RAI 3.6.2.2.2-1a (High Voltage Insulators)

LRA 3.6.2.2.2 Degradation of Insulator Quality due to Presence of Any Salt Deposits and Surface Contamination, and Loss of Material due to Mechanical Wear

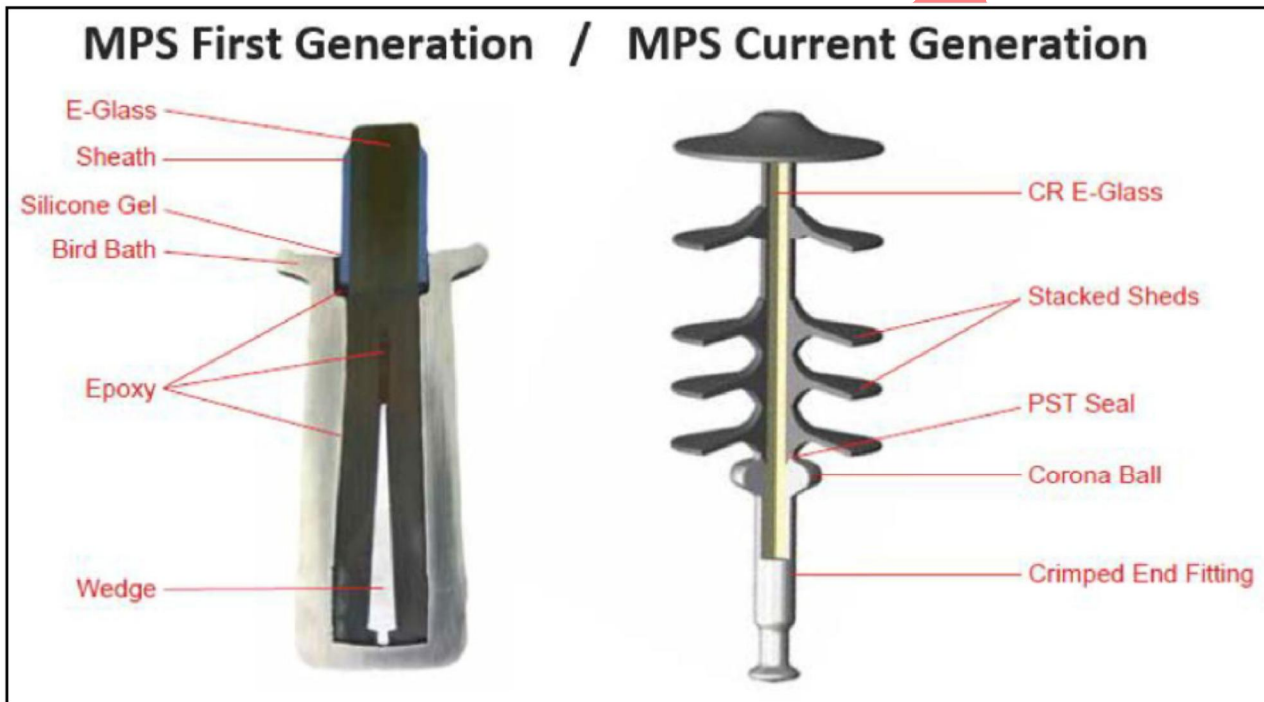
1. Explain why epoxy, silicone gel, sealants, and ductile iron are not listed in the response to RAI 3.6.2.2.2-1 as materials that are used in construction of polymer high-voltage insulators.

The RBS polymer high-voltage insulators are a recent generation of MPS polymer insulators that have been manufactured since 2007. The RBS polymer insulators do not use epoxy. The following figure shows the difference between the first generation of MPS polymer insulators and the generation of MPS polymer insulators that are used at RBS.

The MPS polymer insulators in service at RBS use a PST sealing system, which is a triple seal design. The triple seal or PST seal comprises the primary seal (P), the secondary seal (S), and the tertiary seal (T). The primary seal is a silicone rubber sheath compressed into the chamfer of the crimped end fitting. The secondary seal is RTV (room temperature vulcanizing) silicone applied to the rod, sheath, and end fitting interface. The tertiary seal is a final external RTV silicone seal applied to the sheath and end fitting interface. The RBS polymer insulators do not utilize silicone gel. The response to RAI 3.6.2.2-1 included silicone rubber, but did not explicitly identify RTV silicone as a type of silicone rubber. The silicone rubber material includes the RTV silicone that is part of the PST seal system. The RBS polymer insulators do not include silicone gel or sealants other than RTV silicone.
